DISCUSSION of:

Ground Improvement Using Preloading with Prefabricated Vertical Drains

Bengt H. Fellenius, Dr. Tech., P.Eng., Canada; email: bengt@fellenius.net

Figure 1. Settlement measured at the benchmarks shifted 10 days.

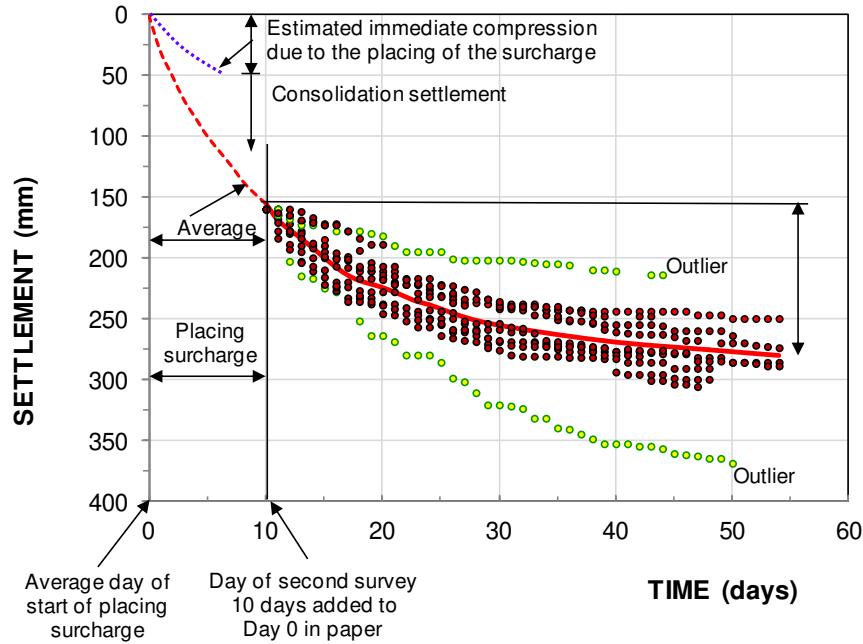
The authors report, that the first survey of the benchmarks was taken before the 3.0-m surcharge was placed across the test area. The first day of settlement measurements for the twelve benchmarks was the date of the second benchmark survey, which was carried out only when all of the surcharge had been placed to the full height over the test area. The time between the first and second surveys—and the placing of the surcharge—ranged from a few days to twenty days. Because the times between the placing of the surcharge and the second survey differed for the benchmarks, the amount of settlement that had occurred at the time of the second survey also differed between the benchmarks. This explains some of the significant scatter displayed in the authors' Figure 13. I have re-plotted the measured settlements in Figure 1 to a common starting point at the average start settlement of 160mm and added 10 days to the authors' measurement days to indicate the average duration of placing the surcharge, which took place before the second survey. During this time, immediate compression and some consolidation will have occurred. As indicated, I estimate the immediate compression to be about 50 mm. I have also added an average curve and extrapolated it back to the origin (the average excludes the two outlier records). All benchmarks appear to show that most of the consolidation had developed at the time the last survey was made.

Figure 2. Settlement measured at the benchmarks normalized to the average end values.

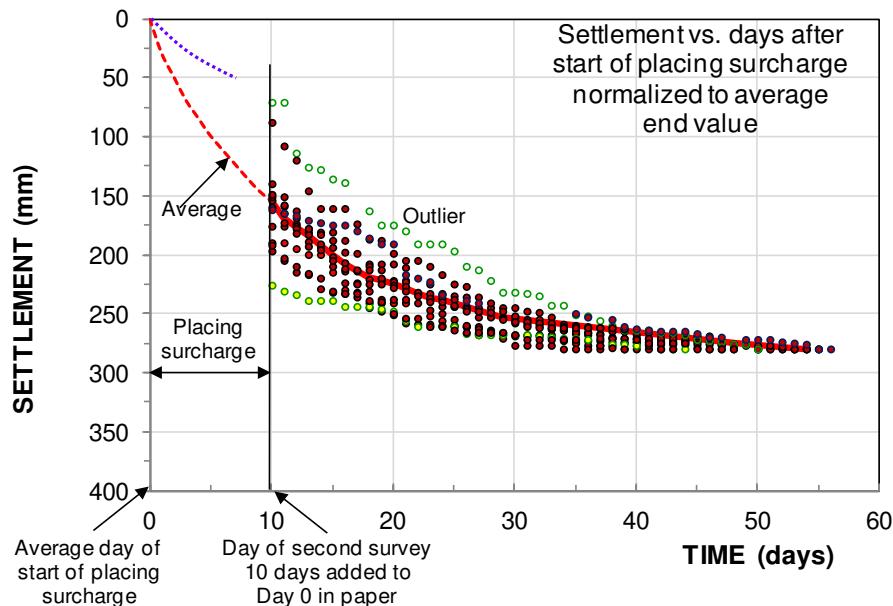
Figure 2 shows the measured final settlements are normalized to the average final settlement (280 mm). There is still much scatter between the curves, but now the approximate start date for each curve can be obtained by sliding the curves left or right until the best agreement to the average curve is obtained as shown in Figure 3. The removal of much of the scatter—the agreement between the time-settlement curves—is of course to some extent fictitious as the benchmark measurements cannot be expected to be all that similar; a natural variation must have taken place, not least with regard to the thickness of the soft clay layer. However, I believe that the figure suggests a reasonably realistic day for the start of placing the surcharge.

Figure 3. Settlement measured at the benchmarks adjusted to obtain the approximate start day.

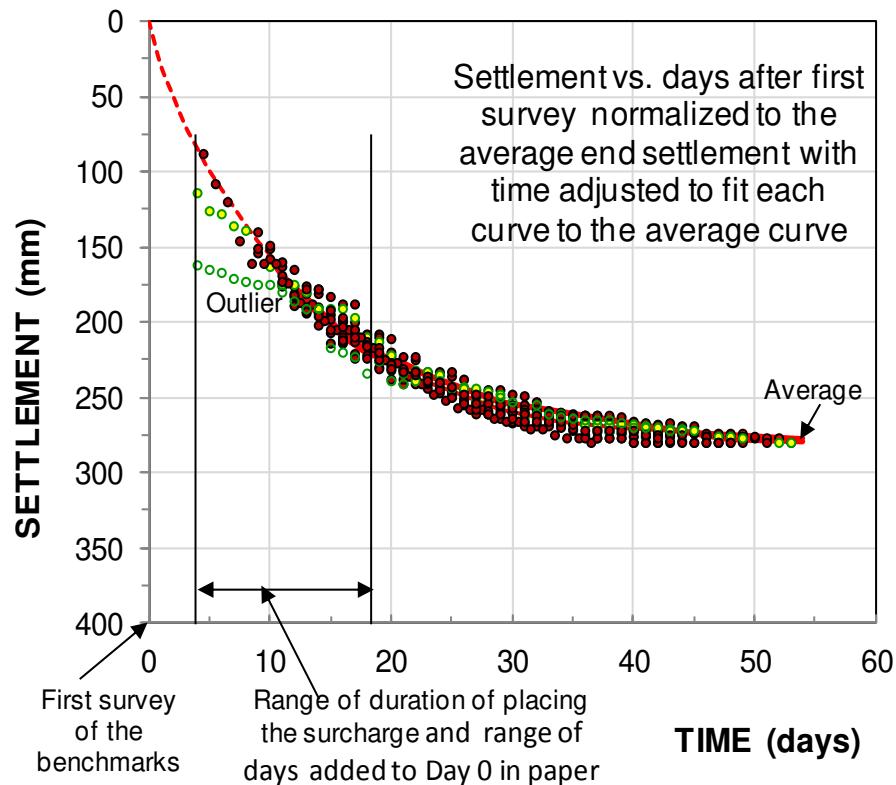
The average curve shown in Figure 3 can now serve as reference to a back-calculation of the time-settlement development for the wick-drain project to determine compressibility and coefficient of consolidation of the soil layers. The back-calculation consists of applying the theory of pore pressure dissipation in fine-grained soils (consolidation) due to radial flow (Barron 1948, Kjellman 1948, and Hansbo 1960; 1979) is based on radial flow toward a circular drain in the center of a cylinder of homogeneous soil with an impervious outer boundary surface). The theory is summarized in the Kjellman-Barron formula, Equation 1. The Kjellman-Barron formula is based on the assumption of horizontal (radial) flow only and a homogeneous soil.

Figure 4. Average measured and calculated settlements.

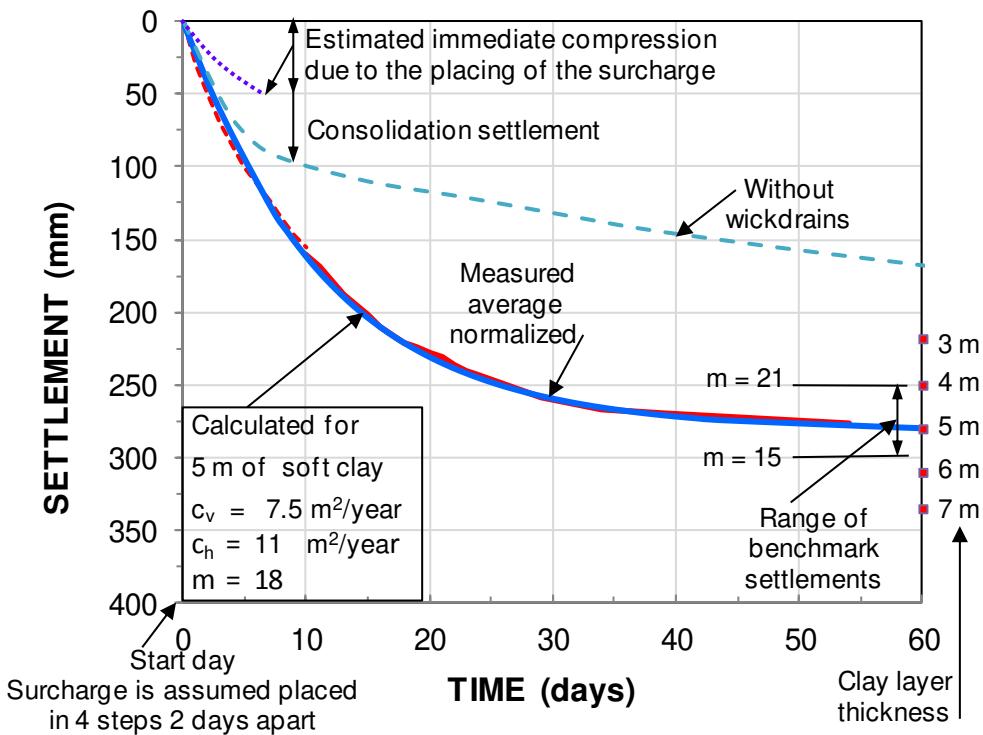
The results of the back calculation are shown in Figure 4 together with the average curve of the measurements. In order to show the sensitivity of the clay layer thickness and modulus number, the figure also shows the final settlement for soil layer thickness ranging from 3 through 7m and the final settlement resulting from modulus numbers of 15 and 21. The figure also shows the settlement during the first 60 days that would have occurred had there been no wick drains (for this input, I used the authors' 7. 5 m^2/year c_v -coefficient).

Considering that my data reduction is quite different to that of the authors, my back-calculated c_h -coefficient ($11\text{m}^2/\text{year}$) agrees well with the authors' laboratory-established value ($14\text{m}^2/\text{year}$). The difference could be taken to represent the effect of a smear zone. However, considering all the uncertainties involved, I believe the agreement to be entirely fortuitous.
